SUBJECT: Forwards response to 830311 request for info re mod to 1C  
 safety injection pump logic. Submittal consists of design  
 criteria & electrical schematics.

Subject: LC Safety Injection Pump Logic  
R. E. Ginna Nuclear Power Plant  
Docket No. 50-244

## Enclosure A

### Design Criteria

O	ORIGINAL	INITIAL DATE	N J 4 3-16-42	8/20/82	8/20/82	8/20/82	8/20/82	ENG. MANG'R.	
NUMBER	REVISION		DRAWN BY	CHECKED BY	RESP. ENG.	SCALE	2		
ROCHESTER GAS & ELECTRIC CORP. ROCHESTER, NEW YORK		GINNA 514 FIGURE I							
		NO. EW 3435

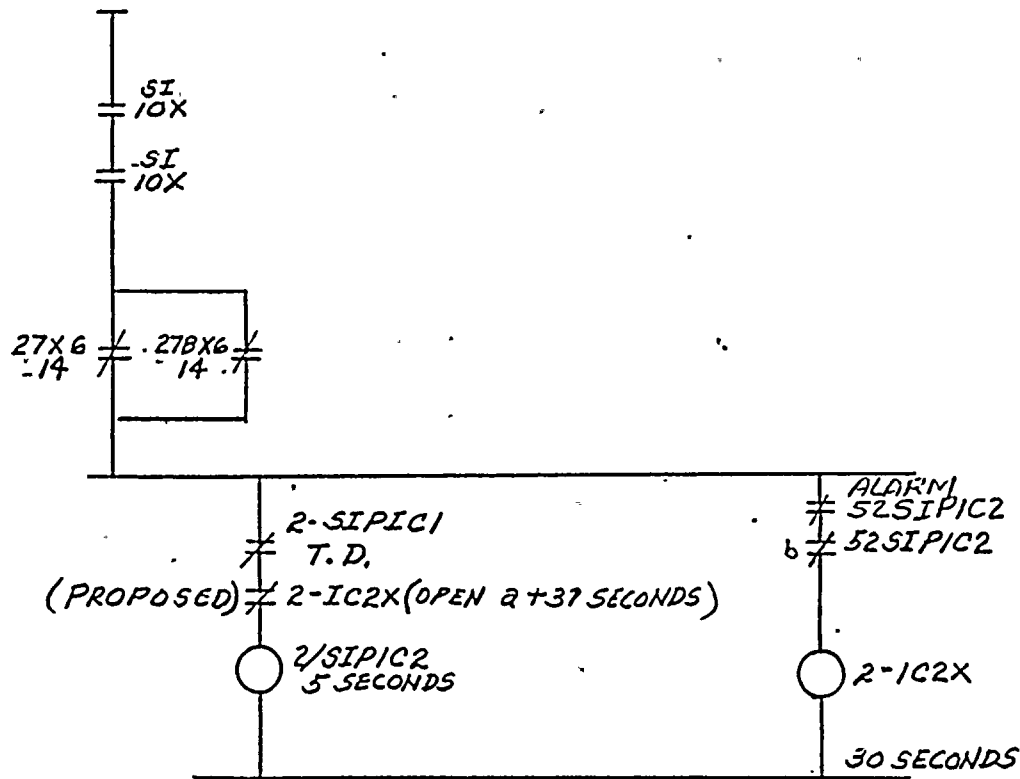
The first set of interlocks consists of instantaneous auxiliary contacts off of time delay relays associated with the 1C SIP breakers. This existing scheme is shown on Figure I. Normal operation of the 1C SIP system begins with a simultaneous SI signal and normal bus voltage. The timers on both systems initially energize, thereby simultaneously deenergizing each other, which through the interlocks, reenergize once again. This sequence occurs until such time as one interlock drops out ahead of the other and thus one timer is locked out. This sequence of instantaneously "picking up" and "dropping out" has the potential of delaying the overall time in which the 1C SI pump finally is placed in service. In addition, the timing relays can be overstressed.

Because the existing configuration is interlocked ahead of the timing relays it results in the unpredictable loading of the 1C SI pump onto either bus 14 or 16.

1	ORIGINAL	INITIAL DATE	10/12/82	GSL	10/12/82	GSL	10/12/82
0	REVISION	DATE	8/20/82	YLP	8/20/82	YLP	8/20/82
			2-16-82				
			DRAWN BY	CHECKED BY	RESP. ENG.	ENG. MANG'R.	
			GINNY STA.				SCALE 1/2
			FIGURE II				NO. EWR3435
			ROCHESTER GAS & ELECTRIC CORP.				
			ROCHESTER, NEW YORK

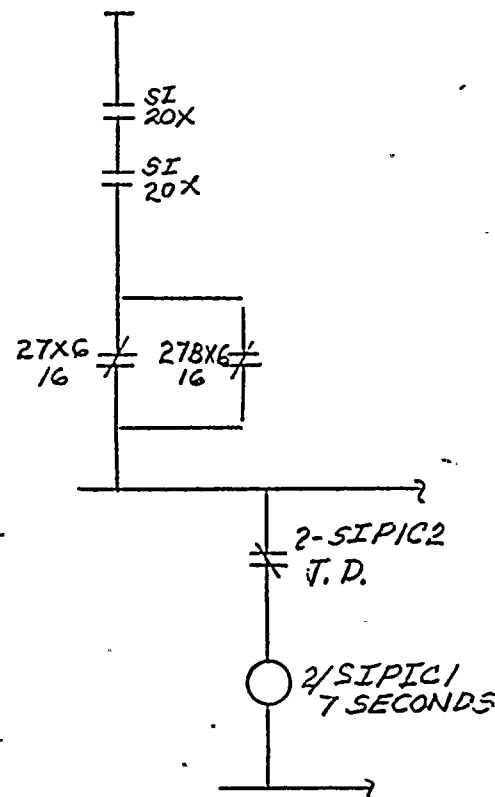
Figure II details this modification, which establishes bus 14 as the preferred source for the 1C SI pump and bus 16 as the backup source, should bus 14 be out of service.

The proposed interlocking contacts are time delayed. That is, they will not open until the relay timers have completed their respective preset delay time. It can be seen that the 1C2 timer is set at 5 seconds while the 1C1 timer is set at 7 seconds. Consequently, the time delayed contacts on the 1C2 timers will deenergize the 1C1 timer in 5 seconds, thus making bus 14 the preferred source for the 1C SI pump motor.

Figure II represents part of the proposed modification which will allow the 1C pump motor to swing to bus 16, should the 1C2 breaker fail to close on bus 14 after a total delay time of 37 seconds. This transfer will not however be allowed if an electrical fault occurs on the 1C motor. This transfer scheme will not subject both trains to a common electrical fault. This is an NRC requirement and must be included in this modification.

The proposed modification to the ESFAS system utilizes a spare TD relay on the A Train Sequencer. The new relay (2-1C2X) will be energized through a "b" contact off of the SIP breaker on bus 14 (52/SIP1C2) coincident with an alarm switch off of the same breaker.

The new timing relay will be set at 30 seconds and it follows the 2/SIP 1C2 timer until it times out and causes the 1C2 breaker to close. If this breaker fails to close within the 30 second period, then the 2-1C2X

will energize and drop out the 2-SIP1C2 timer and allow the 2-SIP1C1 timer to pick up and seven seconds later, the 1C pump will be automatically loaded on bus 16.

The 37 second time delay comes about by using the spare 30 second timer on the A train plus the 7 seconds delay associated with the 1C1 breaker TD relay. Since a single 1C breaker failure is the only postulated failure that must be considered and it is assumed that both the 1A and 1B SI pumps are operational, the total accumulated time delay of 37 seconds is consistent with the Ginna Station FSAR.

O	ORIGINAL	INITIAL DATE	ASM 7/15/82	DNW 7-15-82	9-3-82	9-3-82
	NUMBER	REVISION	DRAWN BY	CHECKED BY	RESP. ENG.	ENG. MANG'R.
ROCHESTER GAS & ELECTRIC CORP. ROCHESTER, NEW YORK			GINNATA		SCALE	
			FIGURE III		NO. EWR 3435

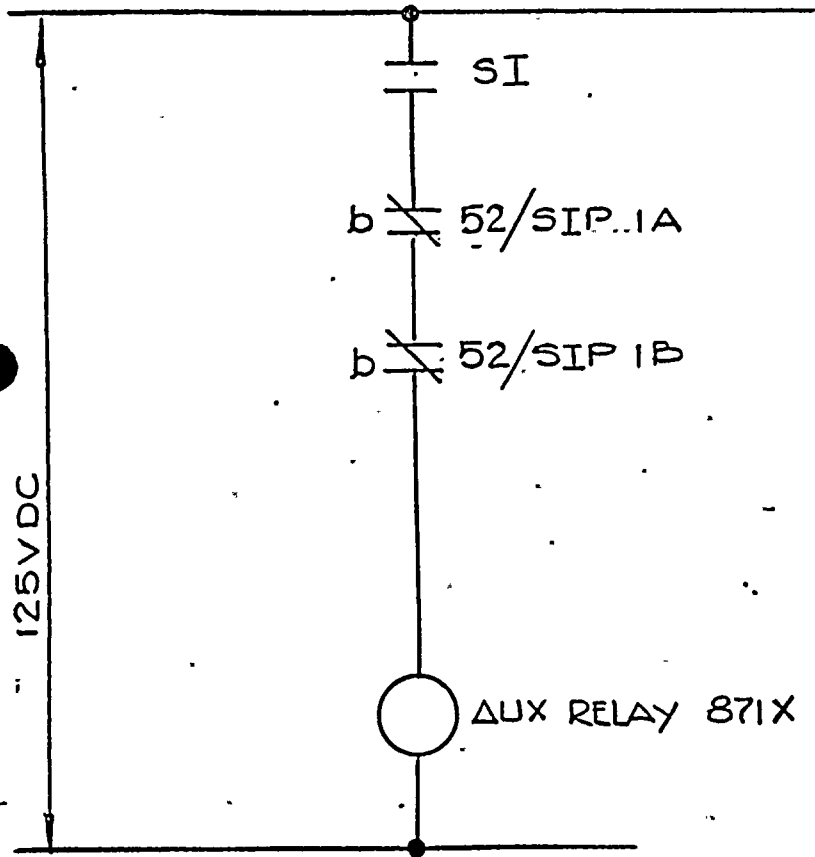
However, in the event that both the 1A and 1B SI pump breakers electrically fail to close after an SI, the 871 A & B valves will automatically go closed, isolating the 1C pump.

The proposed modification will provide valve control logic consisting of an auxiliary relay that energizes only when both the SIP1A and 1B breakers fail to close. This relay will block the auto closure of both 871A & B valves. This logic is only formed during SI. The auxiliary relay, once energized, will prevent the 871 A&B valves from going closed. (Note: 871 A&B are normally "opened"). Figure III outlines the proposed scheme.
